# Access Compliance Report

## Public Rights-of-Way

### (Curb Ramps)

Intersection ID: 10040562	Main Street: W_9TH_ST	Cross Street: N/A	Location: S
ADA ID: BDF12601CE41	Ramp Type: Perp	Initial Pass/Fail: Fail	Overall Compliance: No
Severity Score: 37.5			
Codes/Mitigation Info/Possible Solution		Field Measurements/Component Compliance

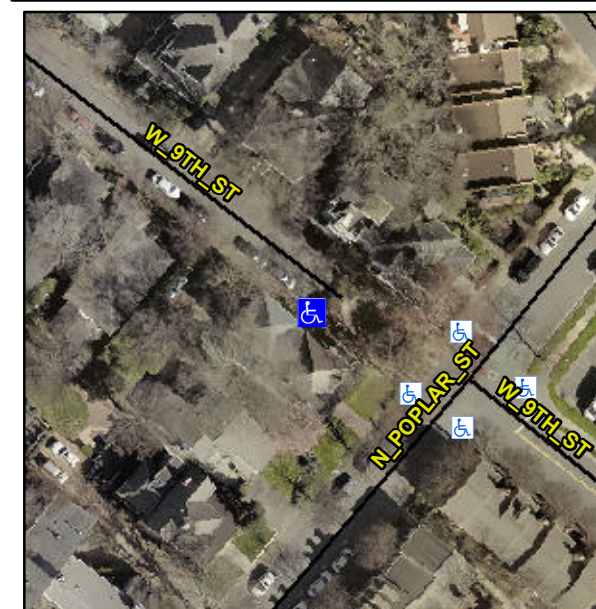
**Not Found, R304.2.2, R304.5.3**

Compliance	Description	Data	Compliance	Description	Data
N/A	Ramp Length (in)	62.0	No	Ramp Slope (%)	10.5
Yes	Ramp Width (in)	50.0	No	Ramp XSlope (%)	9.6
N/A	Flare Type LT	N/A	N/A	Flare Type RT	N/A
N/A	Flare Slope LT (%)	N/A	N/A	Flare Slope RT (%)	N/A
N/A	Flare Traversable LT?	N/A	N/A	Flare Traversable RT?	N/A
N/A	Landing Length (in)	N/A	N/A	DWS Provided?	N/A
N/A	Landing Width (in)	N/A	N/A	DWS Contrast?	N/A
N/A	Landing Slope (%)	N/A	N/A	DWS Length (in)	N/A
N/A	Landing X Slope (%)	N/A	N/A	DWS Full Width?	N/A
N/A	Landing Curb? (Y/N)	N/A	N/A	DWS Offset (in)	N/A
N/A	Shared Landing?	N/A			
N/A	Gutter Ponding?	N/A	N/A	Gutter Slope (%)	N/A
N/A	Gutter Lip Ht (in)	N/A	N/A	Gutter X Slope (%)	N/A
N/A	Painted X Walk1?	No	N/A	Painted X Walk2?	N/A
	X Walk 1 Direction	To N		X Walk 2 Direction	N/A
N/A	X Walk 1 Width (in)	N/A	N/A	X Walk 2 Width (in)	N/A
	X Walk 1 Slope (%)	3.1		X Walk 2 Slope (%)	N/A
	X Walk 1 X Slope (%)	1.6		X Walk 2 X Slope (%)	N/A

**Remove & Replace Entire Ramp.**
